Access Compliance Report Public Rights-of-Way (Curb Ramps)

Main Street: KEMPTON_DR Cross Street: BALLANTINE_DR Location: NW

ADA ID: RPRK211221130516 Ramp Type: Type 1 - Perpendicular Diagonal Initial Pass/Fail: Fail Overall Compliance: No Severity Score: 15

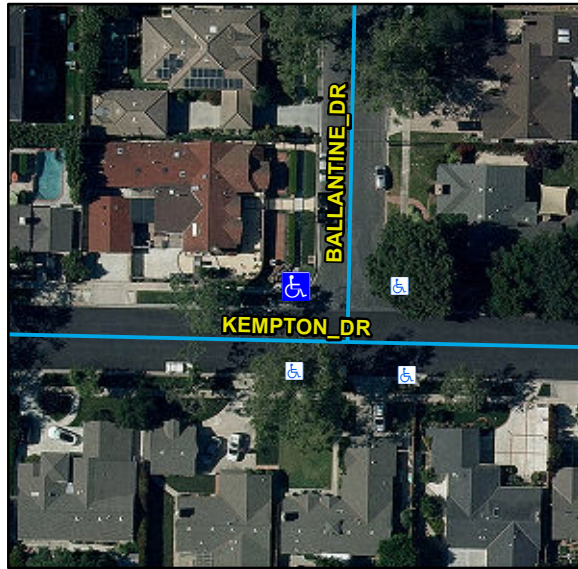
R304.2.2, R204.3, STD 1115

Remove & Replace Curb Ramp With Two New Directional Ramps or Equivalent.
